“WASTEWATER TREATMENT WITH BIOGAS SYSTEM IN PALM OIL MILL AT SAWI, CHUMPORN, THAILAND”

Project Title	Wastewater Treatment with Biogas System in Palm Oil Mill at Sawi, Chumporn, Thailand
Version	02
Report ID	VCS.18.VER.001

Report Title	Verification report for the “Wastewater Treatment with Biogas System in Palm Oil Mill at Sawi, Chumporn, Thailand”
Client	South Pole Carbon Asset Management Ltd.
Pages	52
Date of Issue	20-June-2018
Prepared By	KBS Certification Services Pvt. Ltd.
Contact	Registered Office: 414-424, Om Shubham Tower, Neelam-Bata Road, N.I.T., Faridabad-121001, Haryana India. Contact us at: Tel.: +91-129-4034513, 4054513, 403513, Fax: +91-129-4035139. Webpage: www.kbsindia.in.
Approved By	Kaushal Goyal, Managing Director
Work Carried Out By	Team Leader & Technical Expert: Chetan Swaroop Sharma (TA 1.1, 13.1)

Figure: Monitoring diagram of this monitoring period

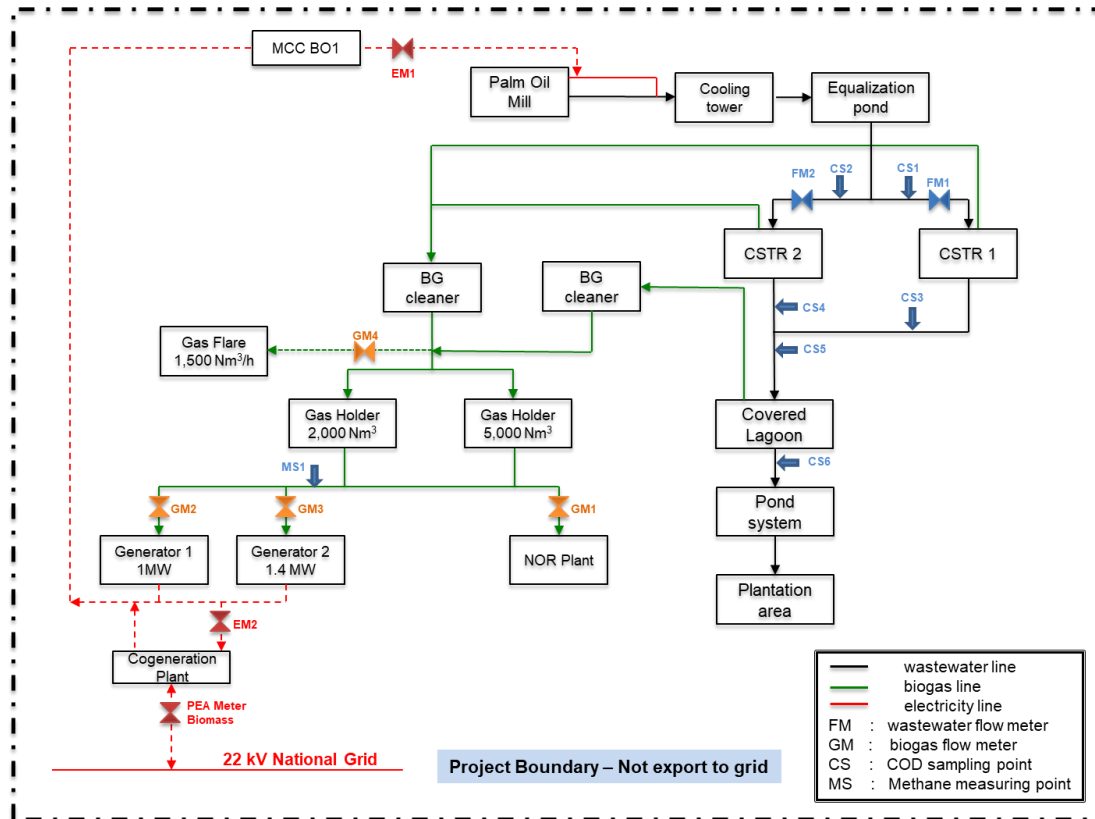
CAR ID	02	Section no.	-	Date: 08/02/2018
Description of CAR				
PP need to mention the monitoring points for all the monitoring parameters (under section 3.2 of MR /xx/) as per figure 2 of the monitoring report.				
Project participant response				Date: 08/03/2018
The monitoring diagram in figure 2 is updated , to add the methane measuring point.				
Documentation provided by project participant				
Monitoring Report				
DOE assessment				Date: 23.03.2018
Also please mention the monitoring points under the monitoring parameters. Open.				
Project participant response				Date: 05/04/2018
The monitoring points are mentioned in the monitoring description.				
Documentation provided by project participant				
Monitoring Report				
DOE assessment				Date: 18.04.2018
The monitoring points are now indicated in the description provided in the revised monitoring report. The issue is closed.
